**Reference is made to Commission Order No. R-3017, recently entered in Case No. 3356, approving the Shell North Square Lake Premier Waterflood Project.**

Re: Case No. 3356

Reference is made to Shell Oil Company's application seeking approval of a waterflood project in the North Square Lake Premier Unit Area. The wells involved are tabulated below:

Well: Shell Trigg Federal #4

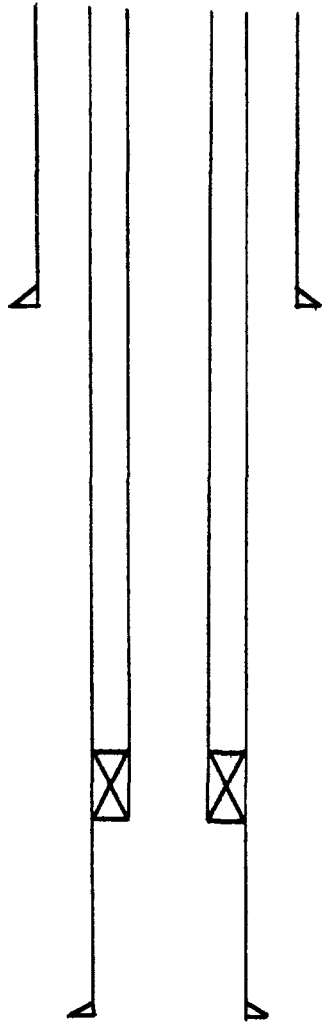
Shell has submitted a revised diagrammatic sketch on the Shell Trigg Federal No. 4 well. The only change from the original sketch submitted is that TD is changed from 3529' to 3550' and plugged back TD is changed from 3550' to 3529'.

This office offers no objection to the granting of the application provided the wells are constructed and equipped as shown on the

diagrammatic sketches for the individual wells and using the revised sketch for the Shell Trigg Federal No. 4 well.
